## Planning Commission Staff Report

**Project Type:** Site Development Section Plan

**Description:** **Spirit Valley Business Park, Lot 9A:** A Site Development Section Plan, Landscape Plan, Lighting Plan, Architectural Elevations and an Architect's Statement of Design for a 1.48 acre tract of land zoned "PI" Planned Industrial District located on the east side of Spirit Valley East Drive, south of Olive Street Road.

**OVERALL LANDSCAPE PLAN**  
SCALE 1" = 20"

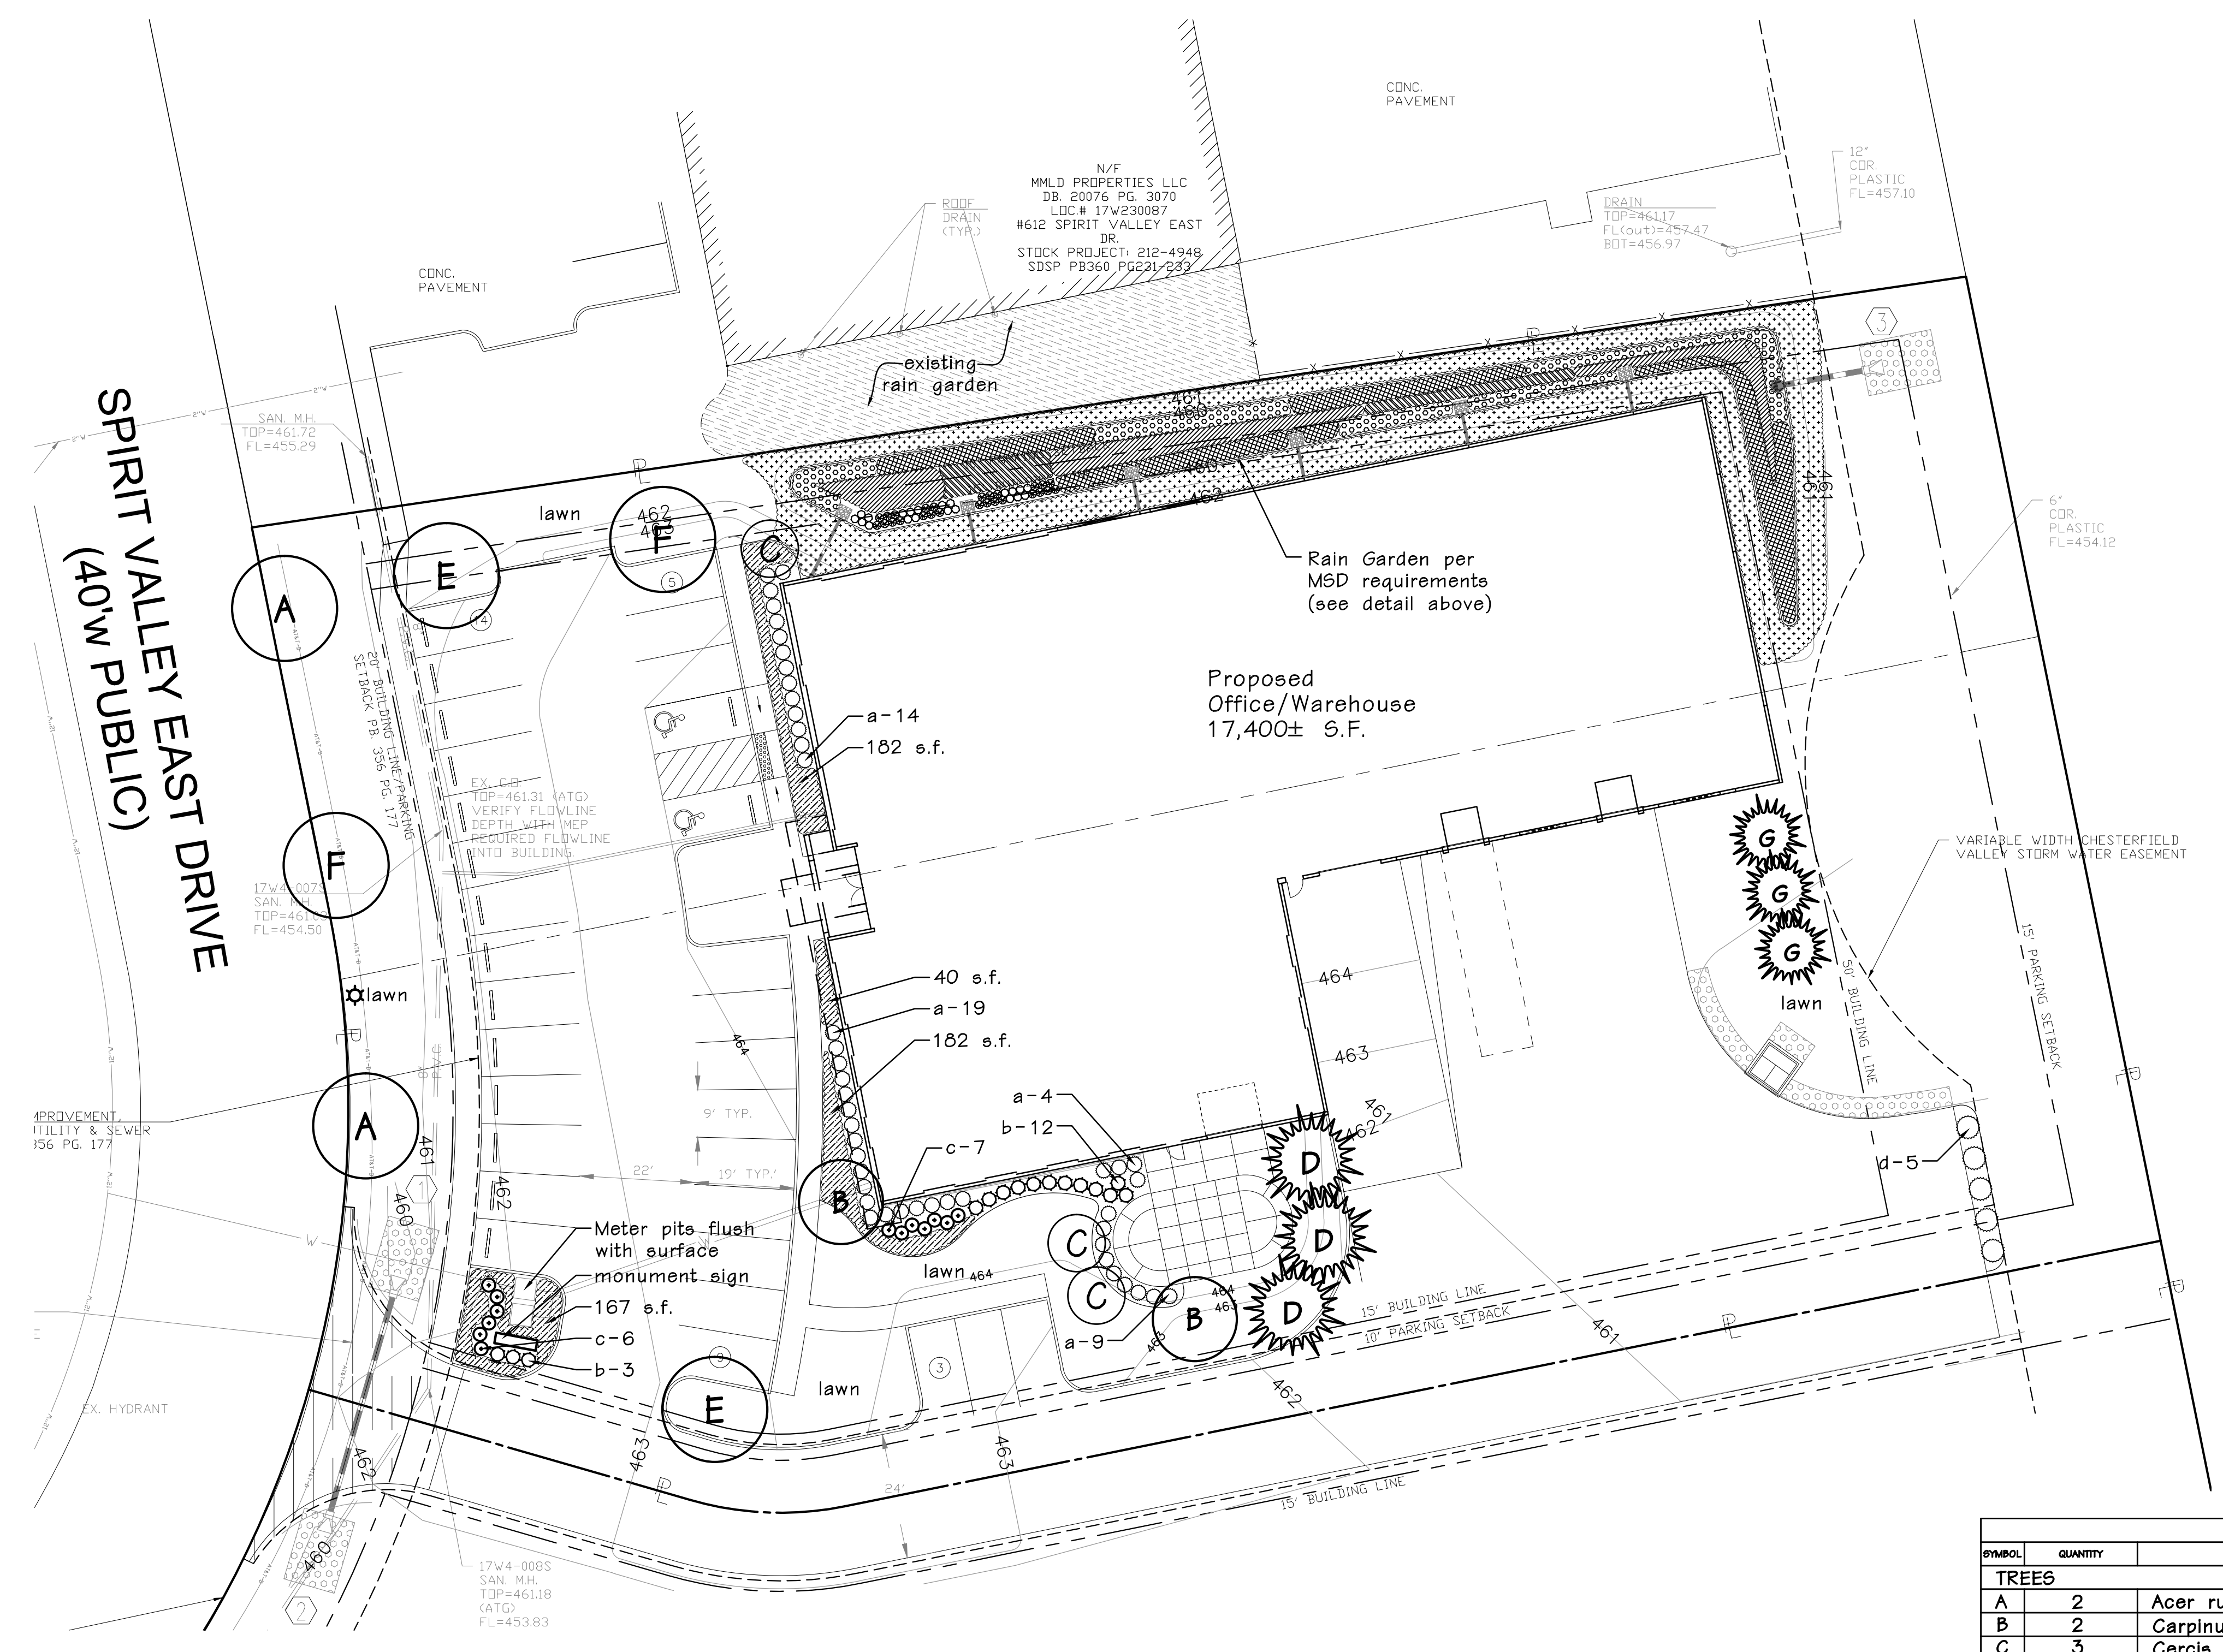
- 2. Add a sidewalk from the parking spaces located along the southern internal drive to the main walkway on the west side of the building. Additionally, relocate the proposed landscaping along the parking stalls to the patio area to provide additional landscaped screening for the patio.*

There was discussion during the Architectural Review Board meeting regarding a safe travel path for those who utilize the three parking spaces along the proposed shared access drive, south of the building. The Board noted individuals who used these parking spaces would have to walk along the shared access drive or across the grass in order to access the sidewalk along the front of the building.

As recommended by the Board, the applicant relocated the proposed landscaping along the parking stalls to the patio area to provide additional screening and added a sidewalk from the three parking spaces to connect to the main sidewalk in front of the building.

SECTION LOOKING NORTH - AT LOW PANEL  
1" = 40'

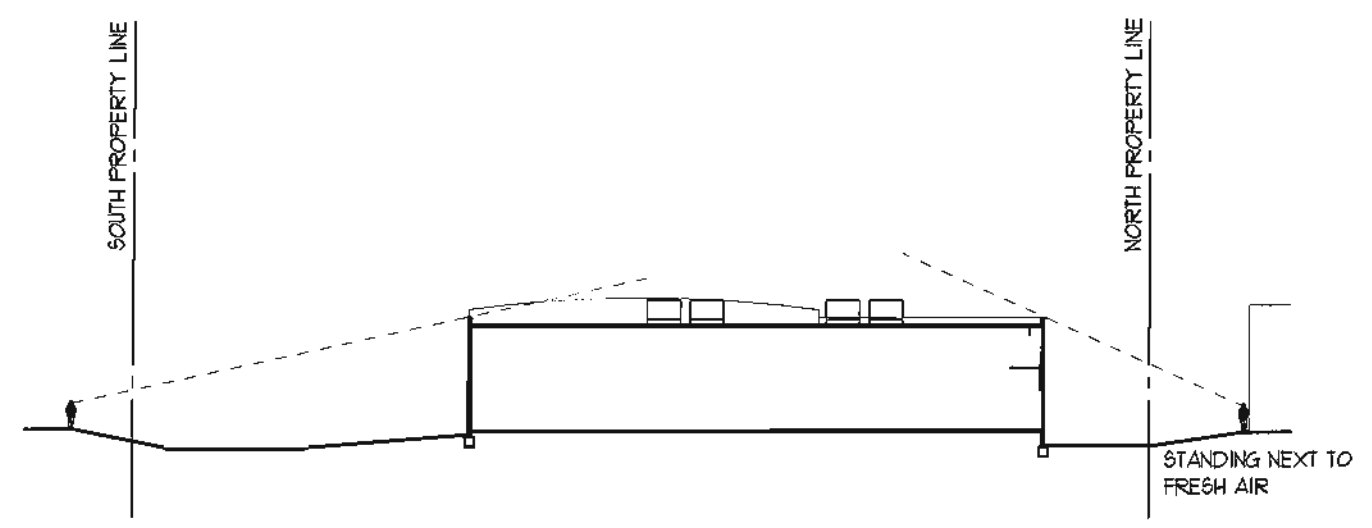
1. *Ensure the rooftop equipment is completely screened by the parapet and provide staff with sight line studies from all property lines.*

The Board noted that the proposed parapet walls were approximately 1.5 feet tall in certain areas of the building and were unsure if the height of the parapet walls were tall enough to ensure the roof-top mechanical units were fully screened, as required by the City of Chesterfield Code.

The applicant provided staff with a sight line study, as recommended by the Architectural Review Board (a copy of this is included with the packet). The sight line study shows the proposed roof-top mechanical units are screened from beyond the property lines of the site and does meet the City of Chesterfield Code requirements.
